MONITORING YEAR 6 ANNUAL REPORT

HENRY FORK MITIGATION SITE

Catawba County, NC
DEQ Contract No. 005782
DMS Project No. 96306
USACE No. 2014-00538
DWR No. 20140193

RE: **Response to MY6 Draft Report Comments**
Henry Fork Mitigation Project
DMS Project # 96306
Contract Number 005782
RFP Number 16-005298
Catawba River Basin – CU# 03050103 Expanded Service Area
Catawba County, North Carolina

Figure 3.0 Current Condition Plan View (KEY)
 Henry Fork Mitigation Site
 DMS Project No. 96306
 Monitoring Year 6 - 2021

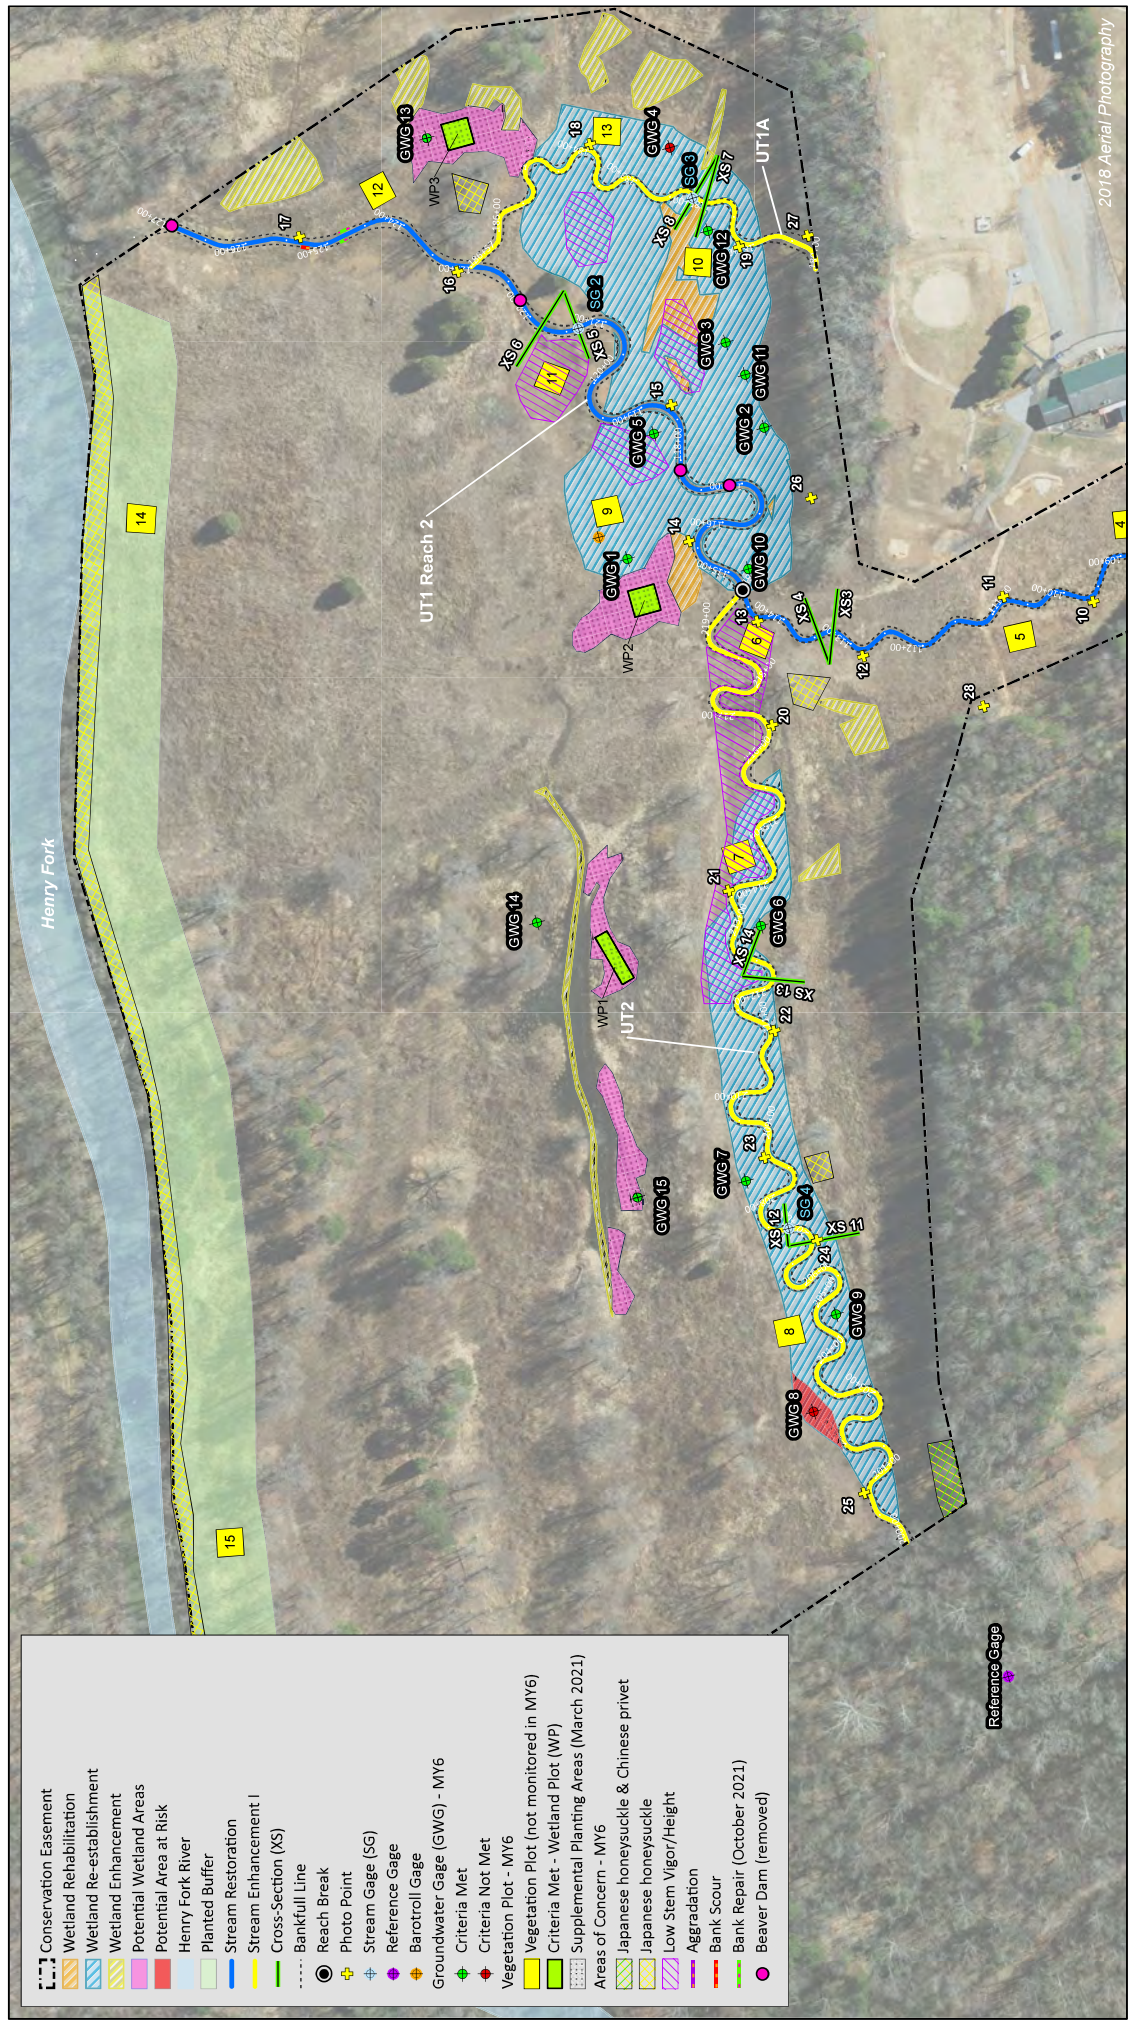
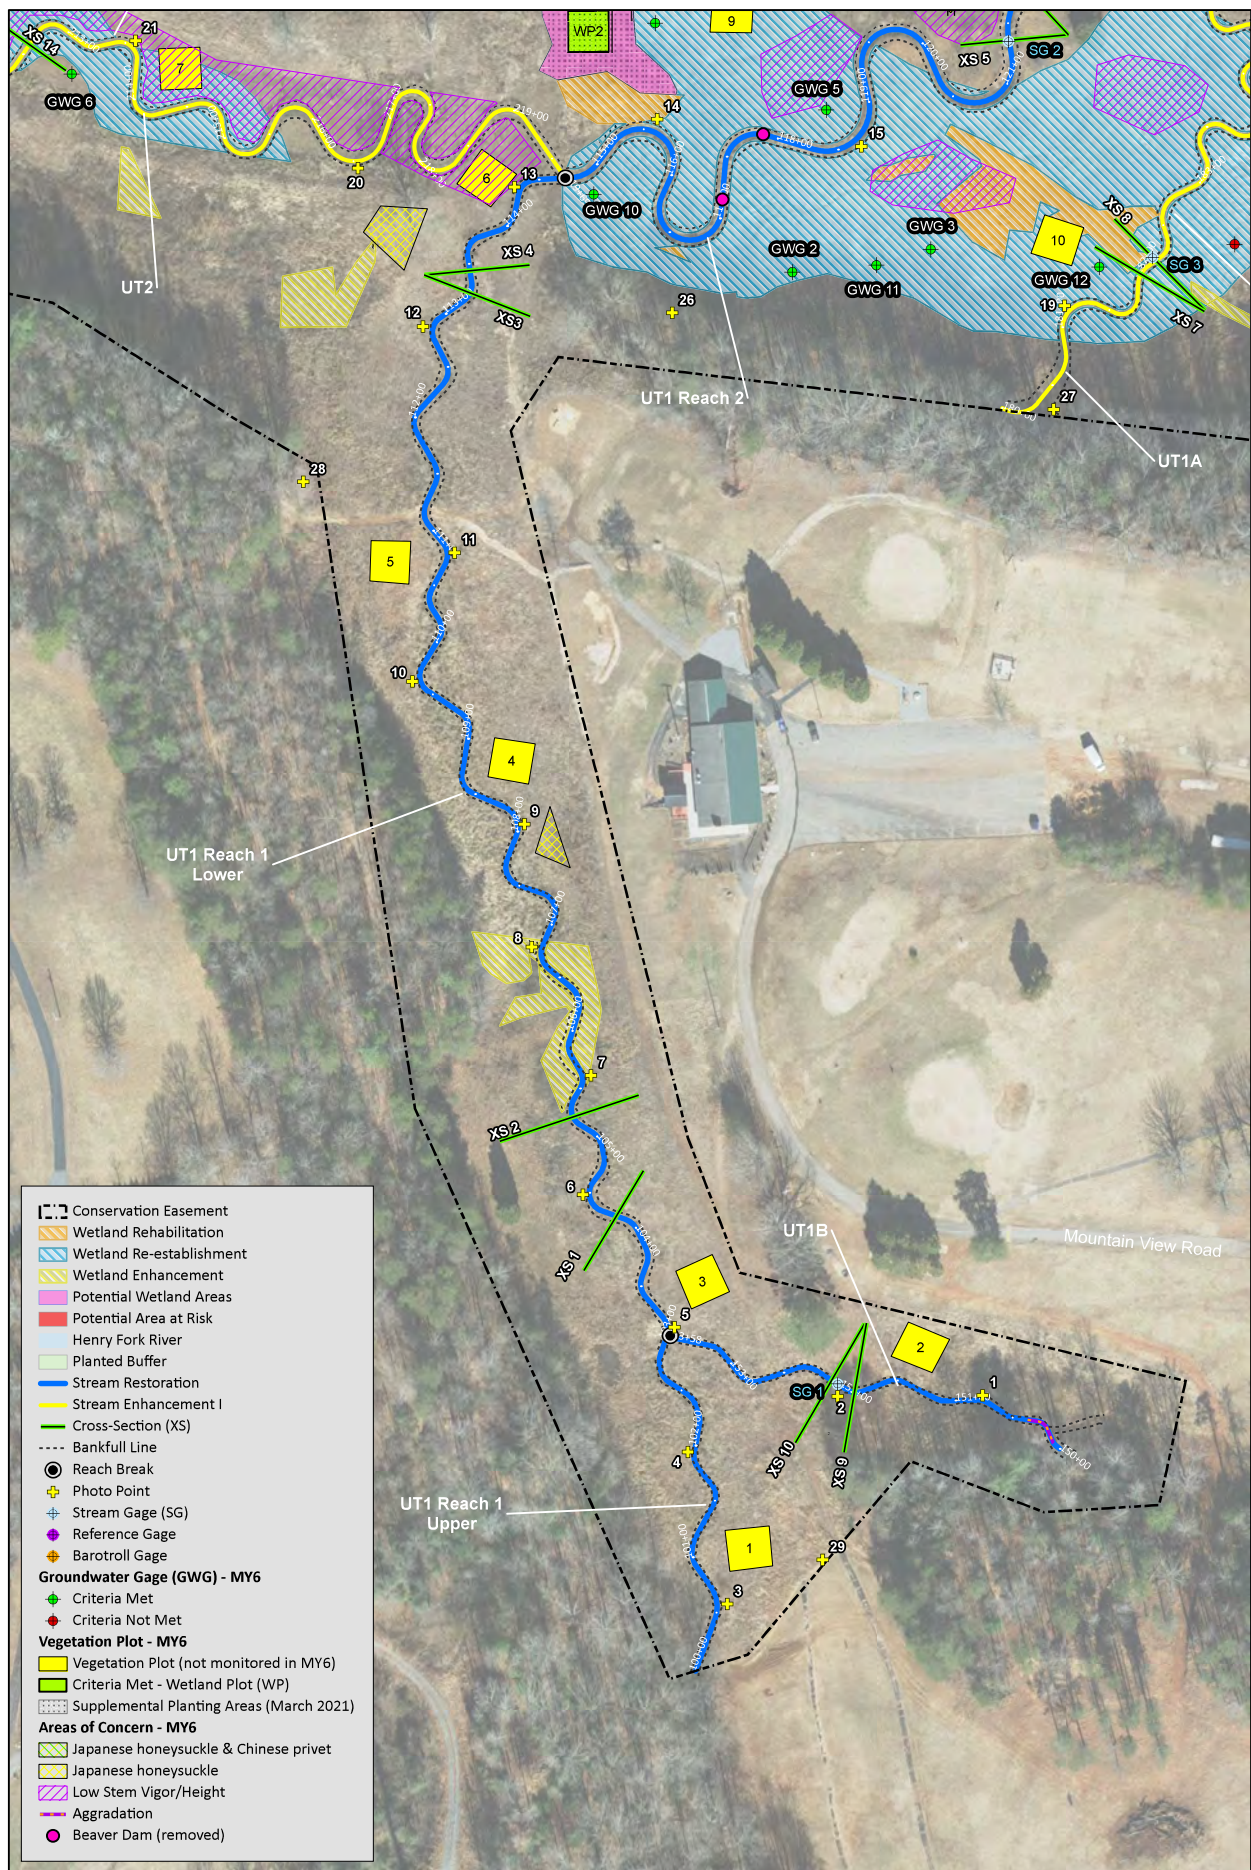
DMS' comment: CCPV: Please add locations of beaver dams that were removed, bank repair location and supplemental planting areas to CCPV.

DMS' comment: Please spatially identify the beaver dams that were removed in Summer 2021. The beaver dam features included in the Stream_AOC feature class appear to be from MY4.

Wildlands' response: The locations of beaver dams that were removed, bank repair, and supplemental planting areas have been added to the CCPV figures.

Wildlands' response: The location of the beaver dams that were removed in Summer 2021 have been added to the CCPV maps and included in the CCPV GIS support files.

Stream Gage Plots
 Henry Fork Mitigation Site
 DMS Project No. 96306
Monitoring Year 6 - 2021

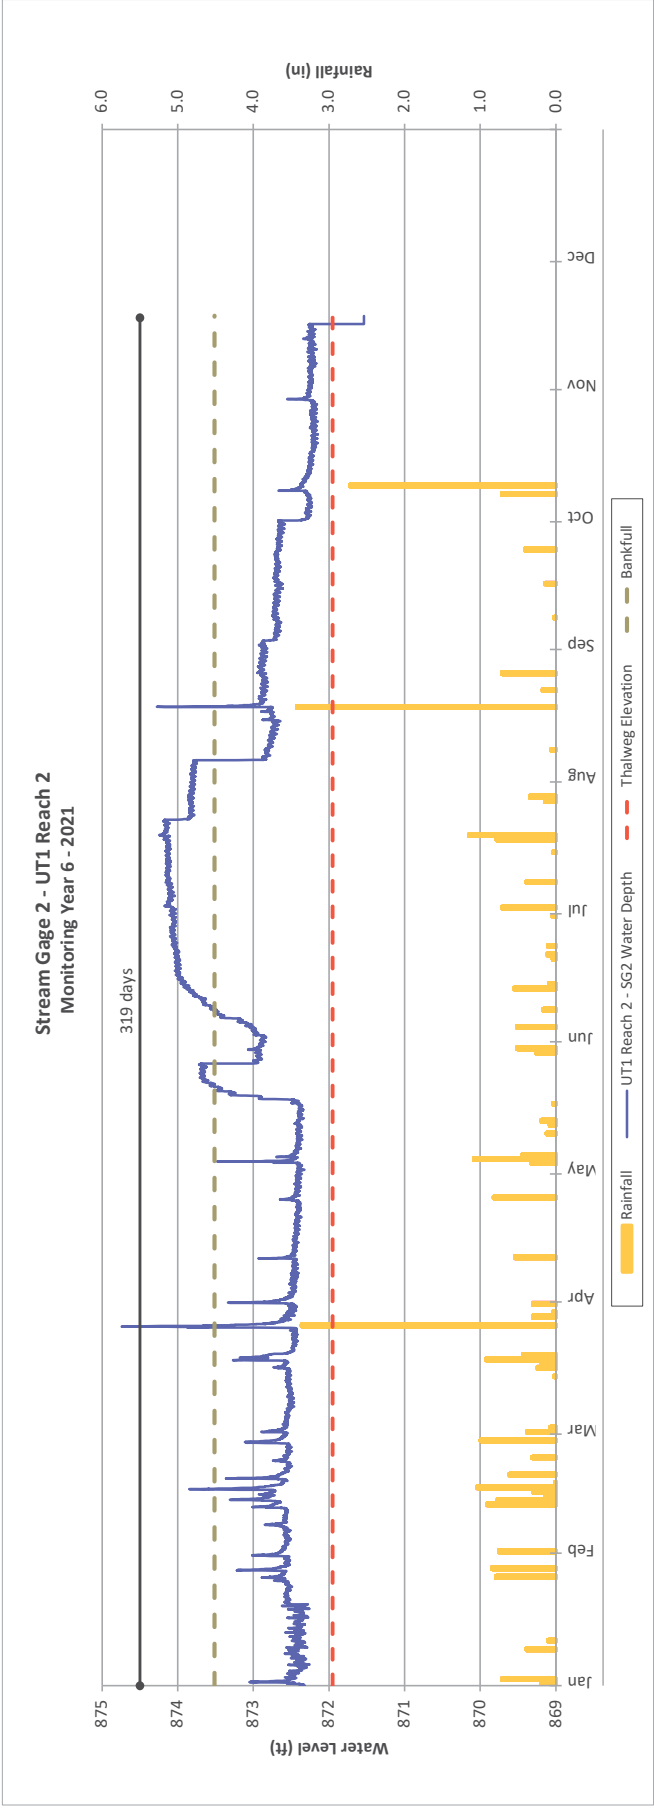
DMS' comment: Stream Gage 2 – UT1 R2: Please add consecutive day bar at top of graph as shown on other gage plots.

Wildlands' response: The consecutive day bar has been added to the stream gage 2 plot for UT1 Reach 2.
